**FLATHEAD COUNTY PLANNING AND ZONING OFFICE**  
**SUBDIVISION REPORT # FPP-13-04**  
**TRUMBULL CREEK CROSSING PHASES 2-5**  
**NOVEMBER 27, 2013**

A report to the Flathead County Board of Commissioners regarding a request for preliminary plat approval of Trumbull Creek Crossing Phases 2-5, a phased major subdivision that would create 113 single family residential lots. Located northeast of Kalispell, the subject property is approximately ¼- mile north of East Reserve Drive and ¼-mile east of U.S. Highway 2.

**Figure 1- Subject property (outlined in blue) and vicinity**

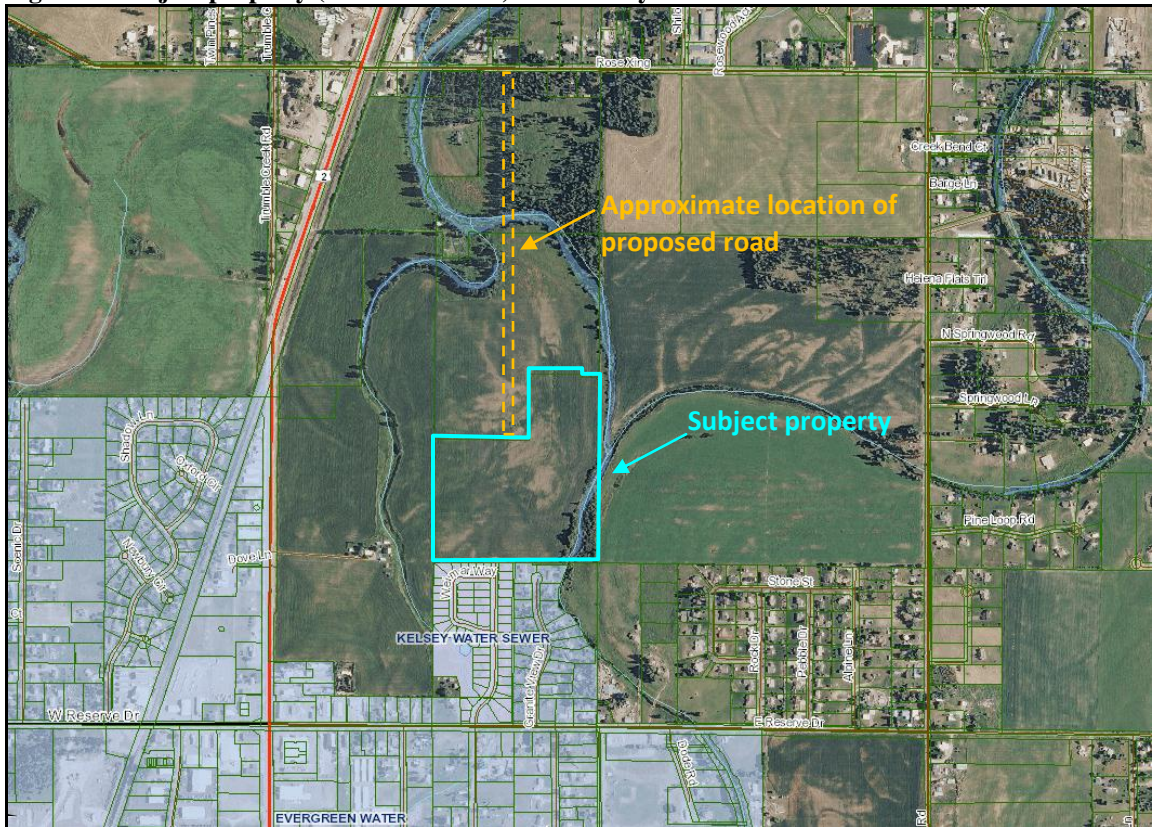
As depicted in various elements of the submitted application and in Figure 1 above, an off-site road extending north from the subdivision boundary to Rose Crossing is proposed to be developed with the third phase (Phase 4) to provide an additional access to the subdivision from Rose Crossing via US Highway 2. Until such time that Phase 4 would be developed for final plat approval, the primary access through Trumbull Creek Crossing Phase 1 via Mountain View Drive would be the only ingress and egress for the 44 lots of proposed Phases 2 and 3.

While the Flathead County Road and Bridge Department indicates no concern with the proposed road extension to Rose Crossing, the Department's comment indicates the road and its crossing over Trumbull Creek would be required to be constructed in compliance with applicable County road and bridge standards and an approach permit would be required for the location where the new road would approach onto Rose Crossing.

24. The applicant shall show proof of a completed approach permit from the Flathead County Road and Bridge Department for the approach of the proposed Phase 4 off-site road extending to Rose Crossing indicating the approach has been built and received final inspection and final approval. [Section 4.7.16, FCSR]

**Figure 2 - Current land use and land cover (subject property shown blue)**

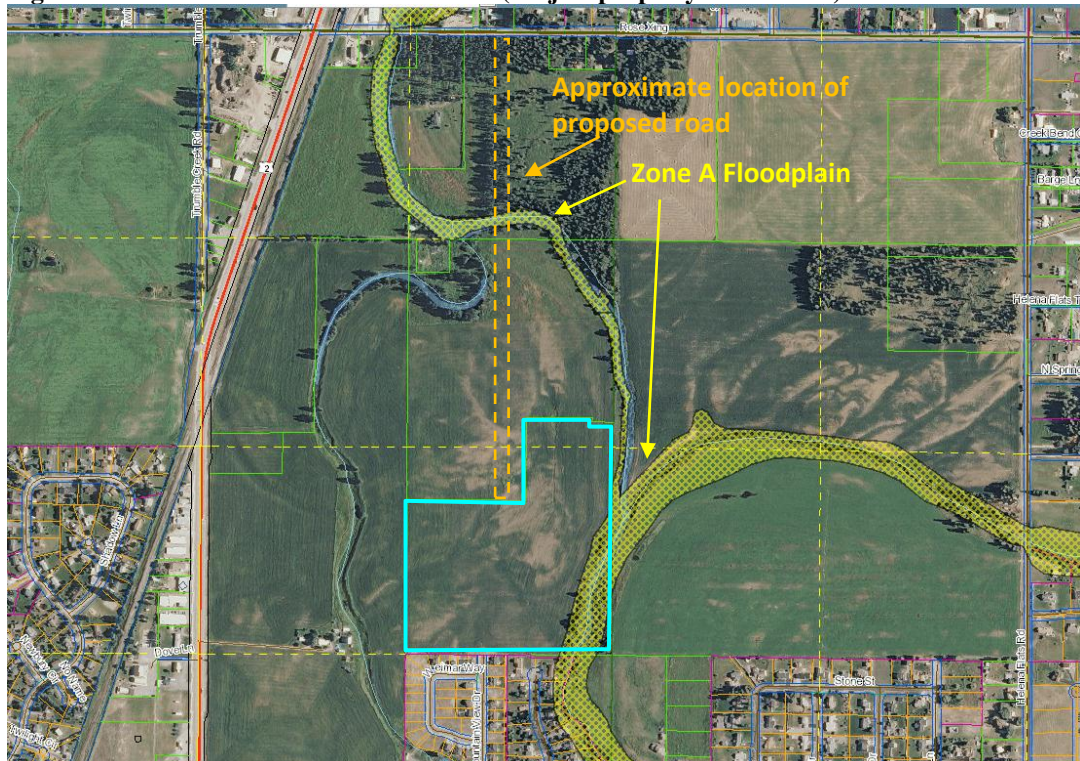
As shown in Figure 2 above, the future offsite road planned to be developed in conjunction with Phase 4 would need to cross Trumbull Creek in order to extend northward to Rose Crossing. While the specific location of the road and the specific design of the crossing have not yet been designed, it is clear that the crossing will interface with Trumbull Creek and its associated floodplain and delineated wetlands.

As shown in Figure 2 above, the future offsite road planned to be developed in conjunction with Phase 4 would cross Trumbull Creek and its associated Zone A SFHA floodplain. A Floodplain Development Permit would be required for development of the stream crossing at the location, and compliance with the terms and conditions of the permit would ensure impacts to the floodplain as a result of the new crossing would be minimized and adequately mitigated.

As shown in Figure 2 above, the future offsite road planned to be developed in conjunction with Phase 4 would cross Trumbull Creek and its delineated jurisdictional wetlands. As the wetlands are determined to be jurisdictional, a

As shown in Figure 2 above, the future offsite road planned to be developed in conjunction with Phase 4 would cross Trumbull Creek and its associated Zone A SFHA floodplain. A Floodplain Development Permit would be required for development of the stream crossing at the location, and compliance with the terms and conditions of the permit would ensure impacts on health and safety due to flood risks associated with the new crossing would be minimized and adequately mitigated.
